TO: PLANNING COMMISSION

RE: Hopeful Heights Vesting Tentative Subdivision Map
2265 Floral Avenue, 15 and 16 Redding Drive (APNs 015-370-003, -067 and -077)

RE: **Vesting Tentative Subdivision Map S 17-03 Hopeful Heights**

**HOPEFUL HEIGHTS VESTING TENTATIVE
SUBDIVISION MAP S 17-03
(A SMALL LOT/PUBLIC STREET SUBDIVISION)**

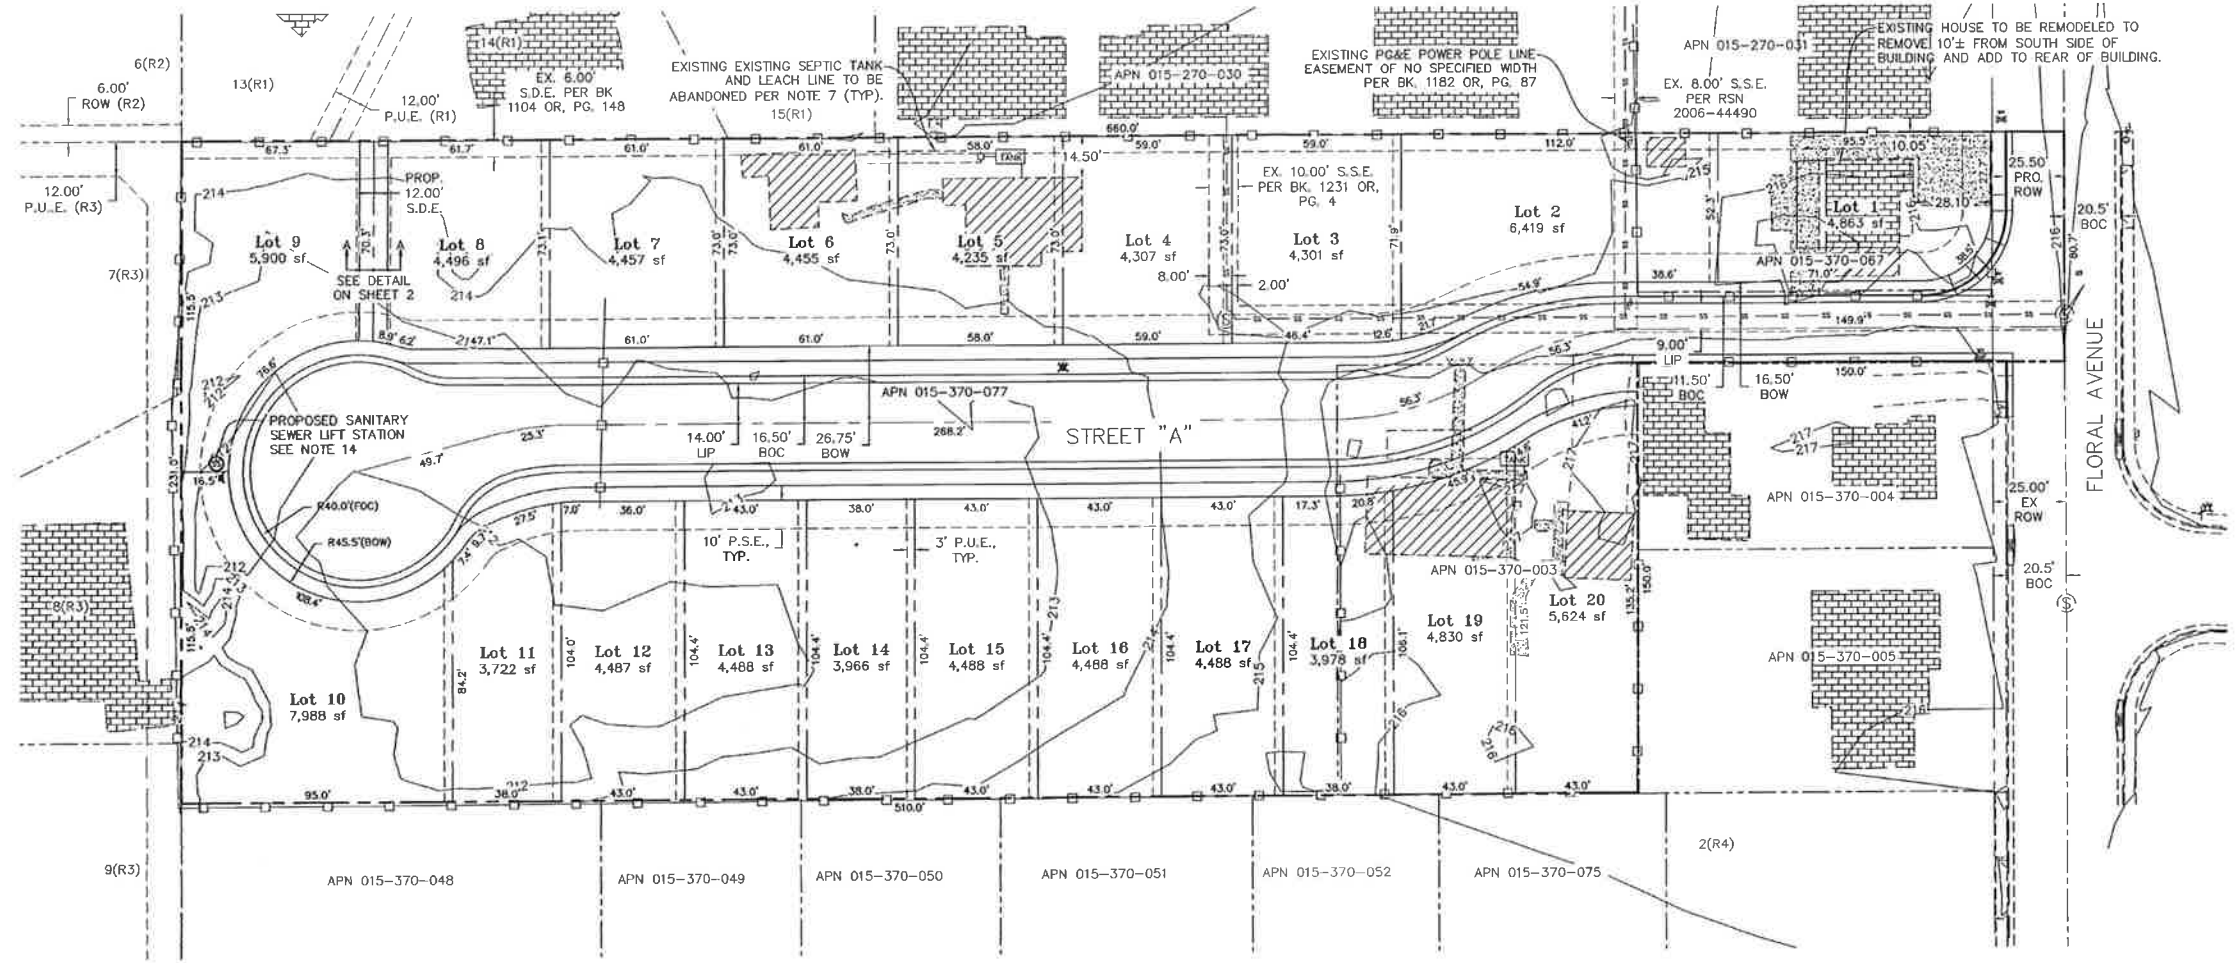
6. The sidewalk terminating at the fence line at APN 015-370-004 shall be redesigned to terminate perpendicular to Street A at the northwest corner of adjacent APN 015-370-004.
7. The developer shall modify Street A to provide a parkway strip at the cul-de-sac bulb between Lots 8 through 11.
8. The developer shall preserve trees #15 and #34, if feasible, and those included in the Tree Table and depicted on Sheet 2 of 2 of the "Hopeful Heights Vesting Tentative Subdivision Map (A Small Lot/Public Street Subdivision) date stamped June 30, 2017. All tree removal shall be subject to the in-lieu fee payment requirements set forth by Chico Municipal Code 16.66 and adopted City fee schedule. In-lieu fees shall be paid prior to issuance of any certificates of occupancy within the project.

1. **Request:** Residential lot depths less than 80 feet.

2. **Request:** Non-right angle and non-radial lot lines.

3. **Request:** Non-standard street cross-sections.

4. **Request:** Non-standard horizontal street alignment.

5. **Request:** Cul-de-sac length longer than 500 feet.

Recommendation: Acceptable.

Recommendation: Acceptable.

Recommendation: Acceptable.

Recommendation: Acceptable.

Recommendation: Acceptable.
